Addendum

SPRINGS AT FREMAUX TOWN CENTER
SLIDELL, LA

DRAWING TITLE FIRST FLOOR PLAN - CLUBHOUSE

1 FRONT ELEVATION - CLUBHOUSE
SCALE: 1/4"=1'-0"

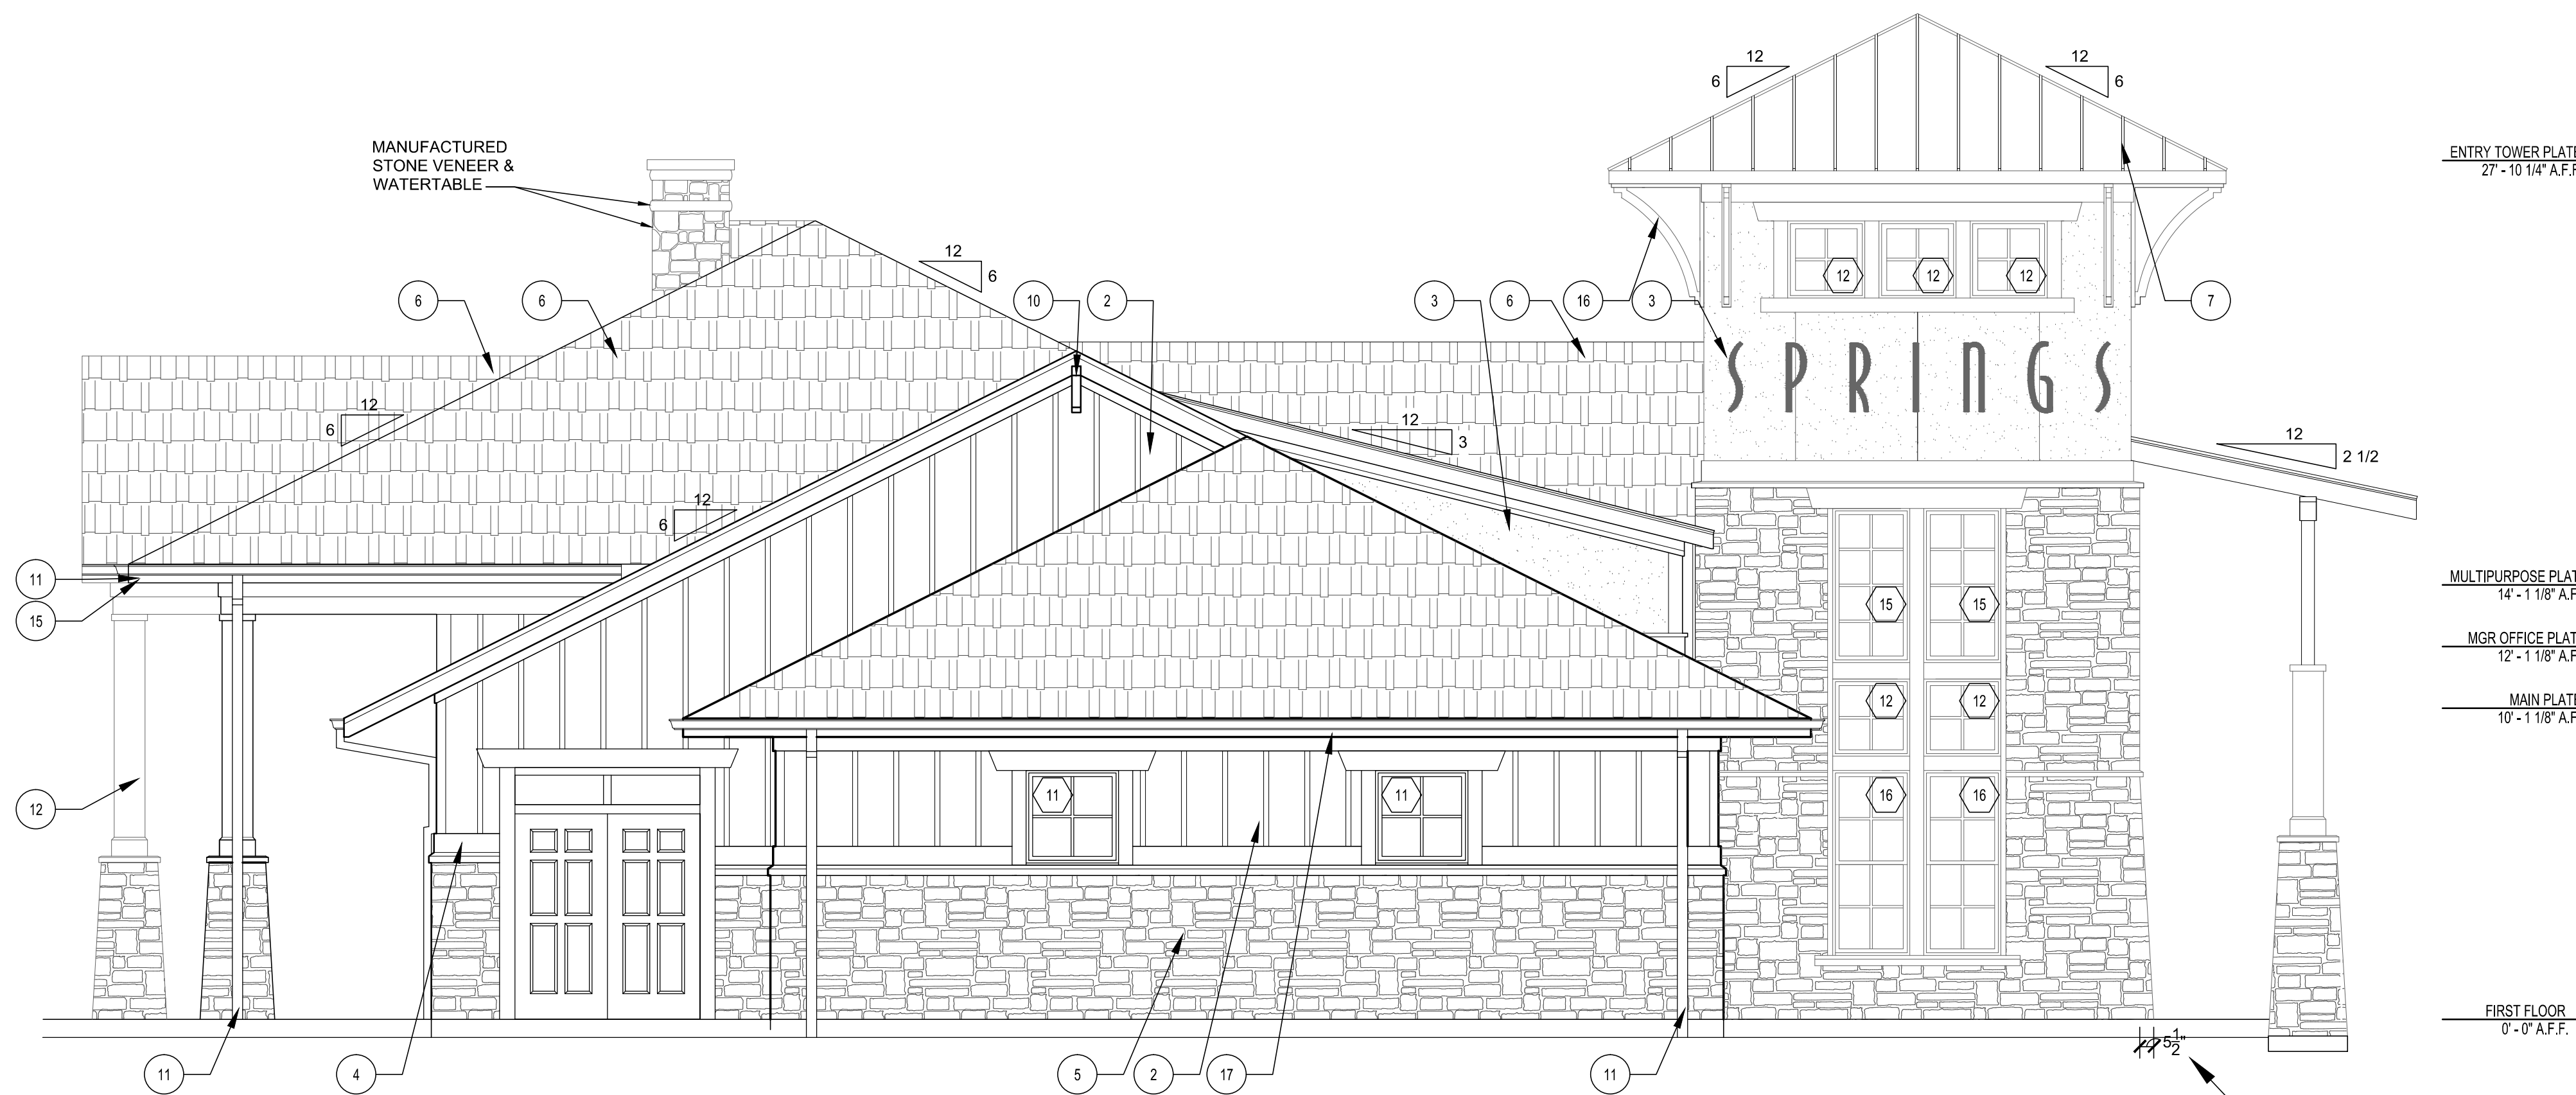
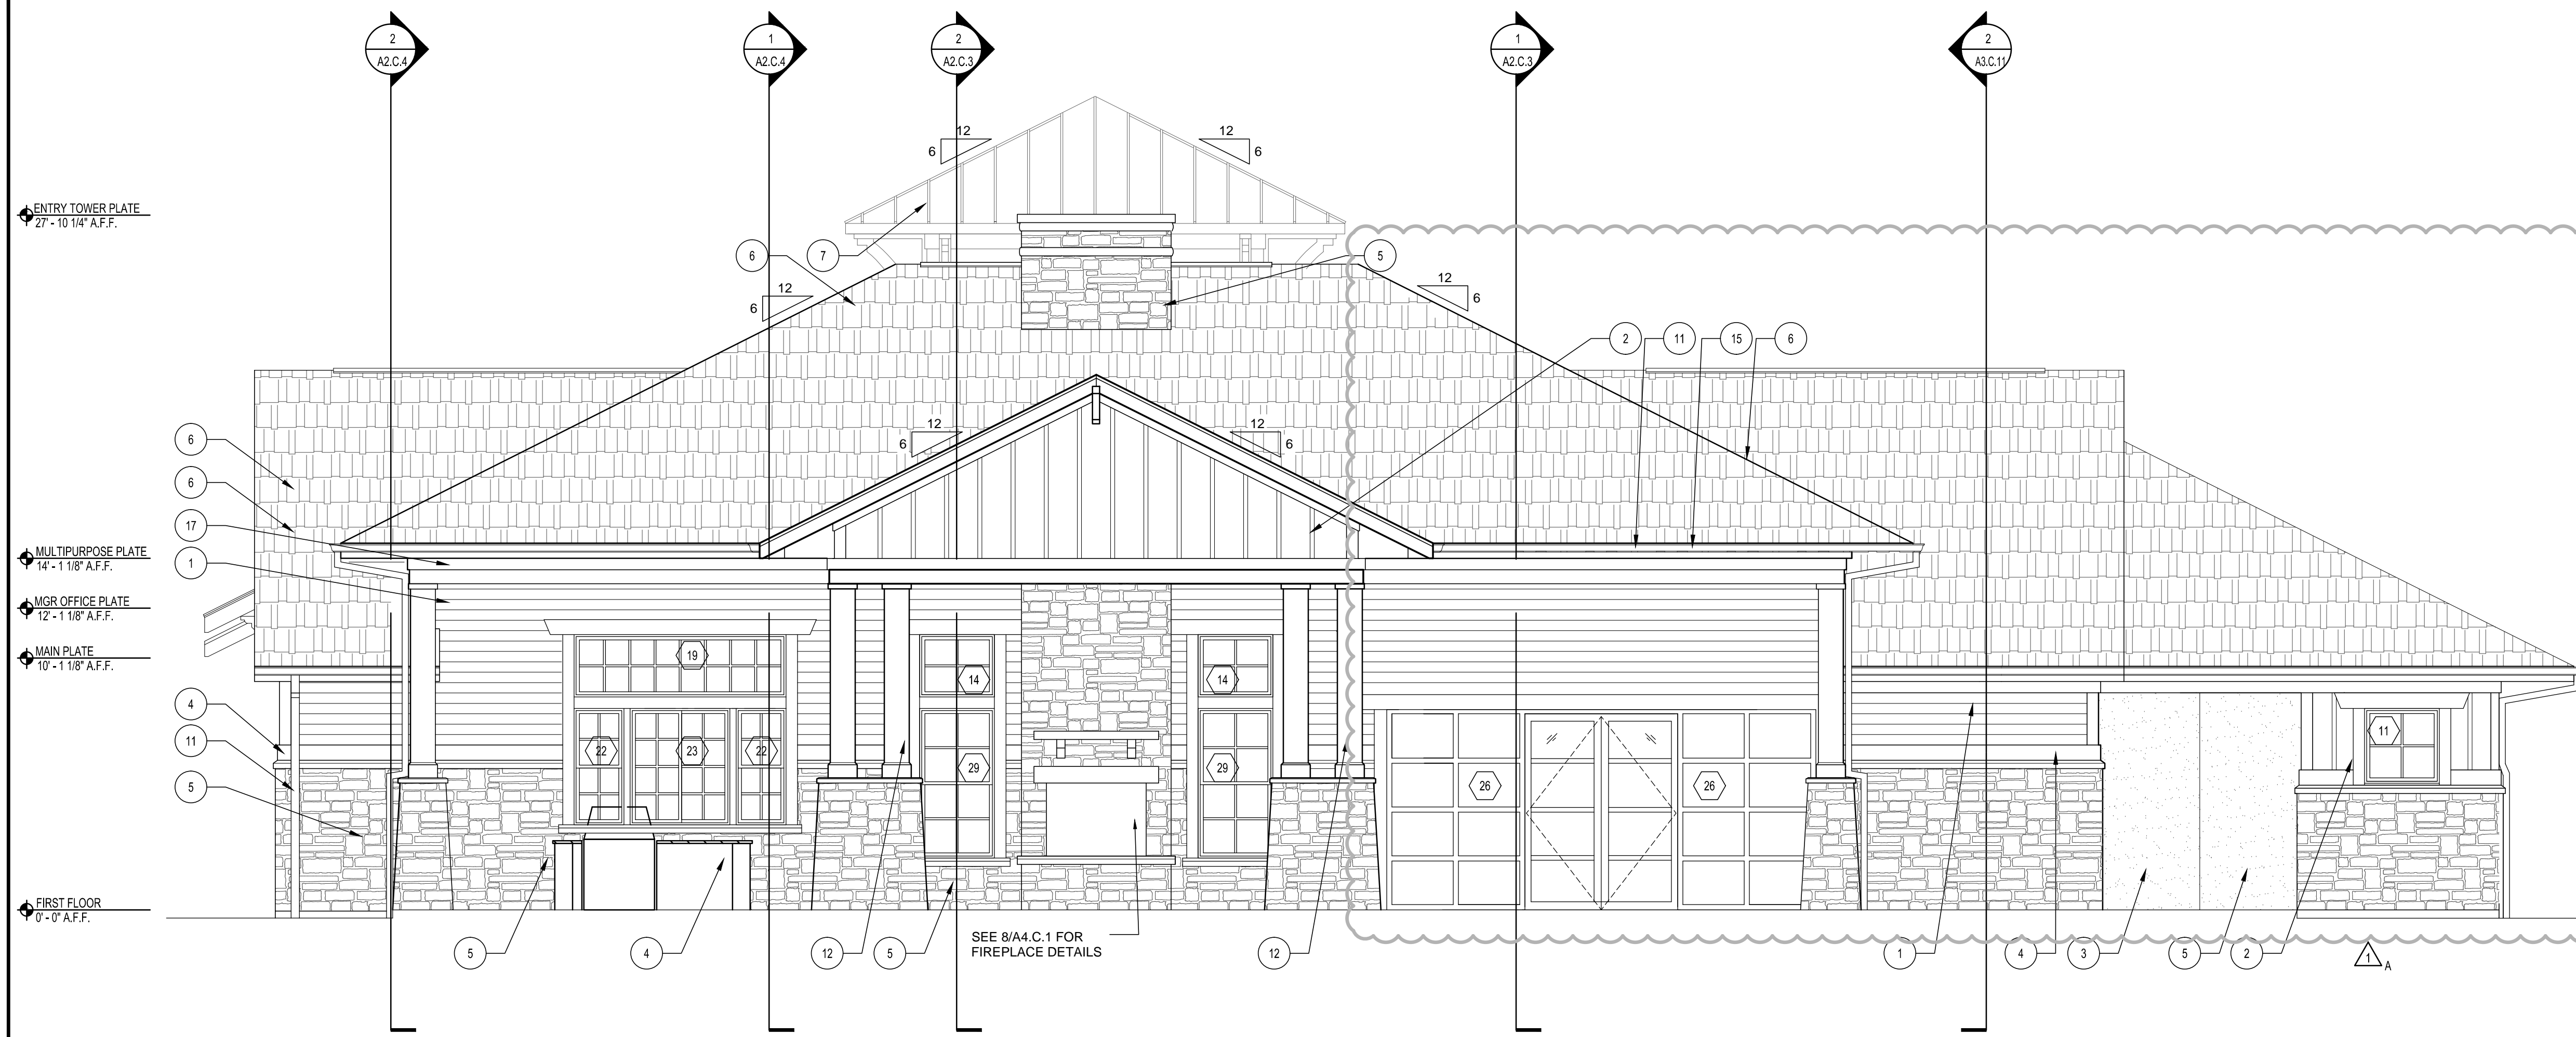
- A. UPDATED FRONT ELEVATION TO COORDINATE WITH ADDITIONAL FLOOR PLAN AREA

1 REAR ELEVATION - CLUBHOUSE
SCALE: 1/4"=1'-0"

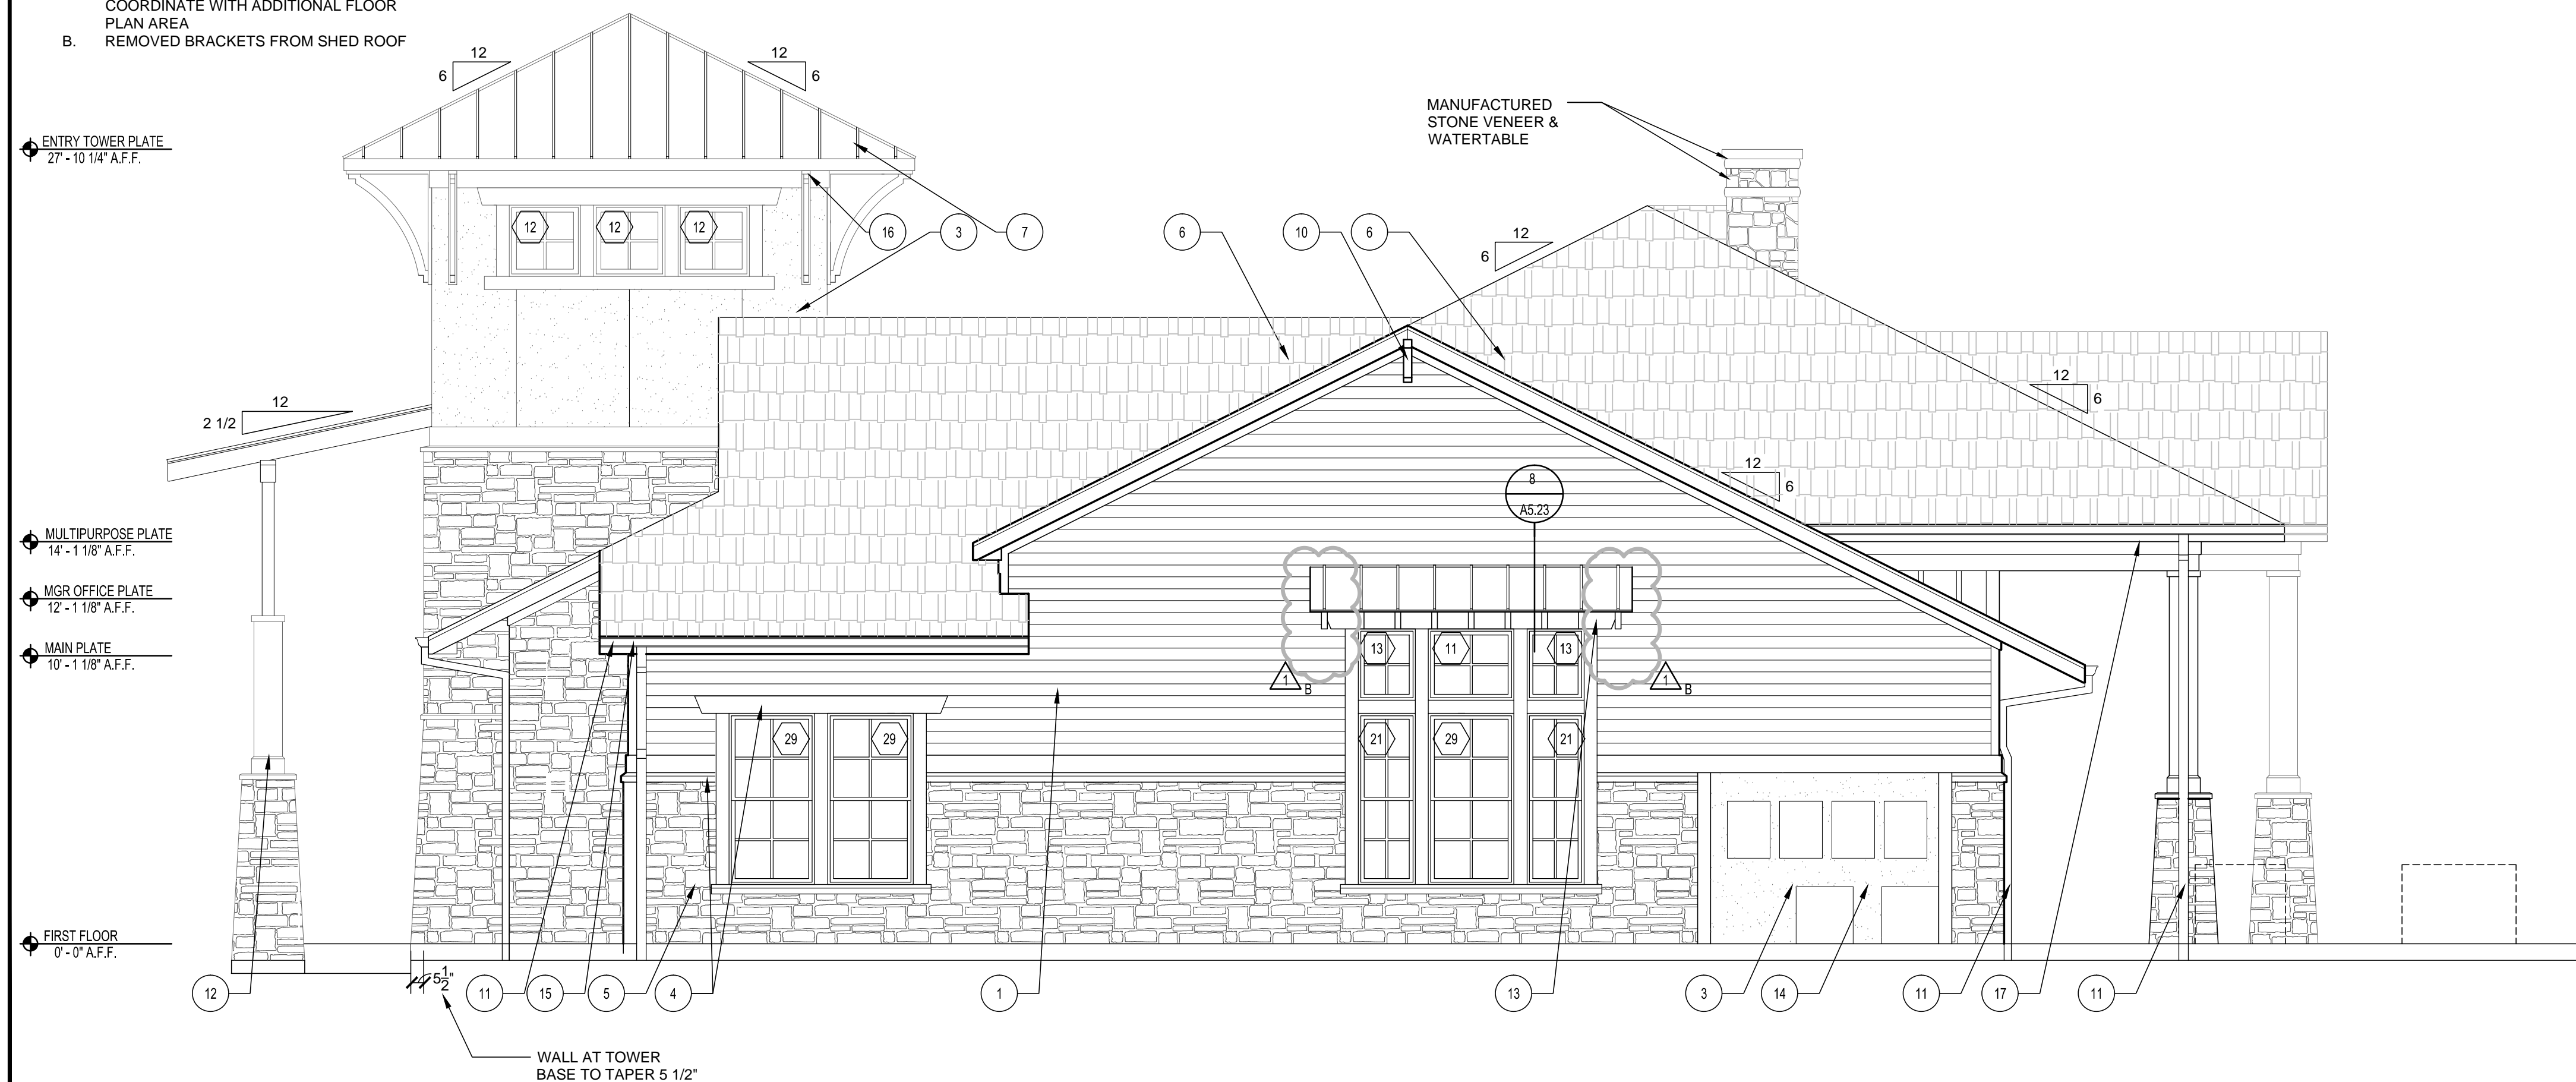
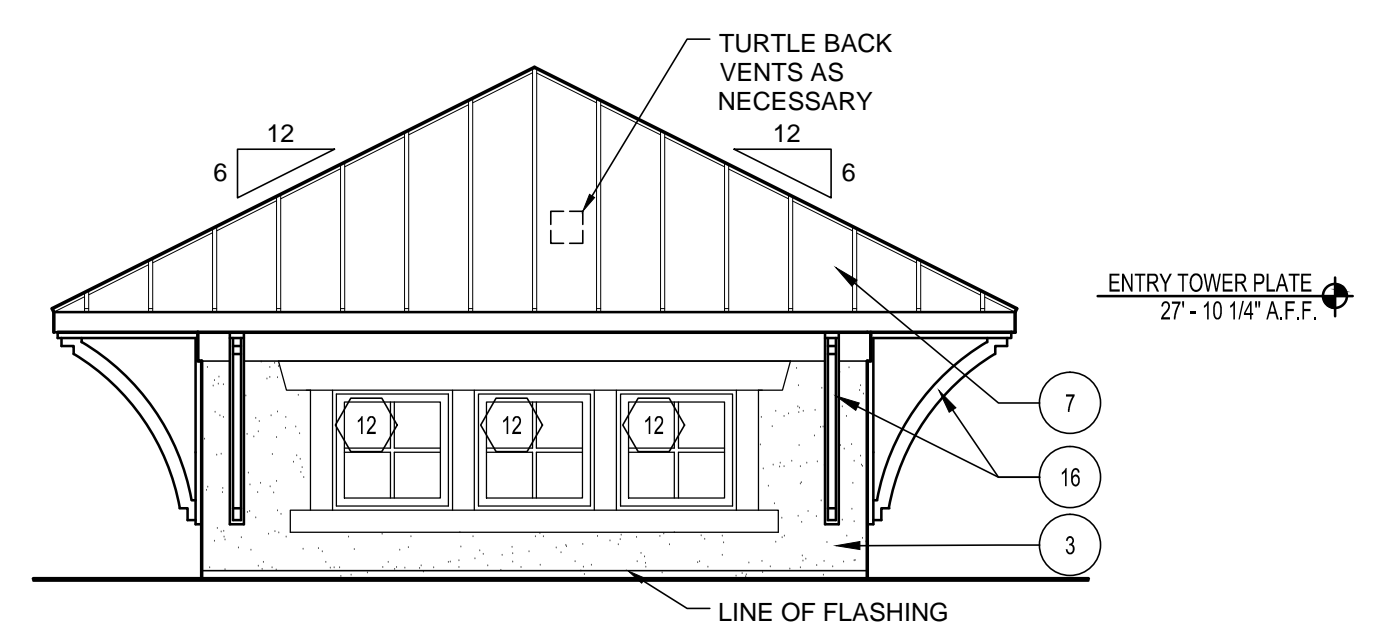
- A. UPDATED FRONT ELEVATION TO COORDINATE WITH ADDITIONAL FLOOR PLAN AREA
- B. REMOVED BRACKETS FROM SHED ROOF
